RS-06-019

Subject: Response to NRC Request for Additional Information With Respect to Request for License Amendment Related to Application of Alternative Radiological Source Term

**BRAIDWOOD STATION  
UNITS 1 AND 2**

**BYRON STATION  
UNITS 1 AND 2**

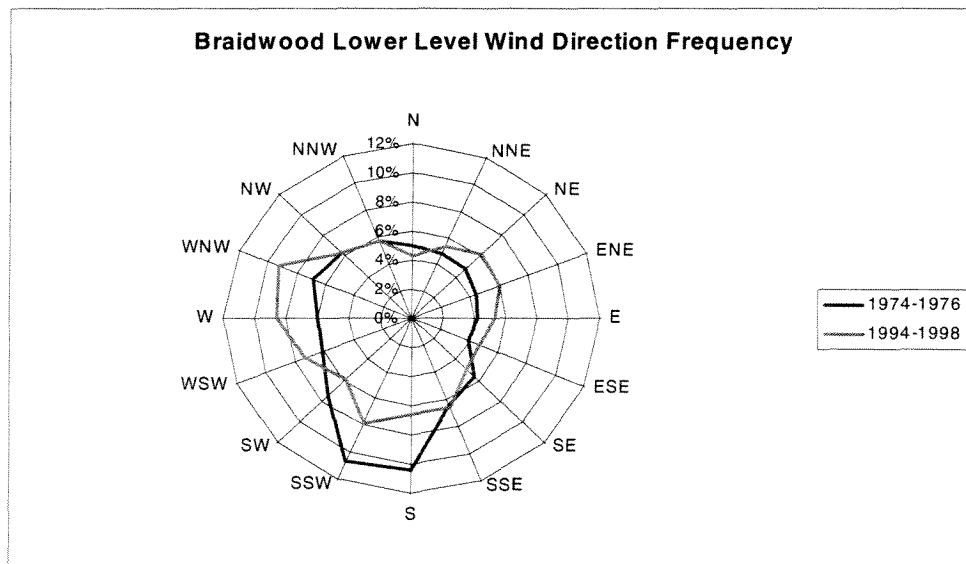
2. A wind rose comparing the Braidwood lower level wind direction frequency distributions between the 1974 - 1976 data presented in Braidwood Updated Final Safety Analysis Report (UFSAR) Table 2.3-4 and the 1994 - 1998 data presented in Attachment 8 to your application letter dated February 15, 2005, is provided below:

This wind rose shows considerable discrepancies for the following wind direction sectors:

Period of Record	Wind Direction Sector			
	S	SSW	W	WNW
1974 - 1976	10.3%	10.7%	5.9%	6.8%
1994 - 1998	6.6%	7.7%	8.5%	9.1%

Please explain what might have caused these discrepancies in reported wind direction frequency distributions between the 1974 - 1976 and 1994 - 1998 data sets (e.g., changes in tower structure and/or boom orientation, vegetation growth, etc.) and the potential impact on the resulting atmospheric dispersion analyses.

Murray and Trettel, Inc. (the Exelon Generation Company, LLC (EGC) meteorological contractor) first began maintaining the meteorological equipment in 1975 and began providing reports based on data collected from May 1975 to present.

The period of record from 1974 through 1976 utilizes only three full years of data. The period of 1994 through 1998 utilizes five full years of data. The smaller data set associated with the 1974 through 1976 data may have had some impact on the wind direction sector frequencies. The wind direction sector frequencies for 1994 through 1998 are more consistent with what would be anticipated based upon known geographic location and topography.

The 1974 through 1976 data set was obtained prior to plant startup in 1987 and 1988. At that time, the man-made cooling lake had not been completely constructed and did not have any water inventory that could have affected local meteorology. Although this may only have affected the wind speed due to less ground friction, it is uncertain if it could also have affected the wind direction.

There were no changes in tower structure, boom orientation, or obvious instrumentation issues that could account for the lower level wind direction shift over the previous 20 years. There is no significant vegetation in the immediate vicinity of the meteorological monitoring tower. Routine calibrations and maintenance were performed on the required meteorological monitoring tower instruments. Murray and Trettel, Inc. noted that the lower level wind sensors were replaced in November 1993.

An additional review of the Braidwood Station meteorological tower (lower level) year-by-year wind direction percentage occurrence frequencies for 1994-1998 shows that there is a relatively higher degree of variability with respect to wind directions SSW, W and WNW than the other directions as shown in the Table below. These happen to be three of the four directions associated with the percentage occurrence "discrepancies" identified by the NRC. The Table shows that the maximum wind direction occurrence is either SSW or WNW in each of the five years. The Table also indicates that annual occurrence frequency varies more for these two directions than the others. West, the second most frequent wind occurrence direction, is third highest in annual variation.

While there may be other factors contributing to the differences identified by the NRC in the 1974-1976 and 1994-1998 Braidwood Station meteorological tower databases (e.g., topographical changes to the site environs), the natural climatological variability cannot be excluded as a significant contributor.

The 1994-1998 Braidwood Station lower level wind direction data set is considered more representative of current conditions than the 1974-1976 data set.
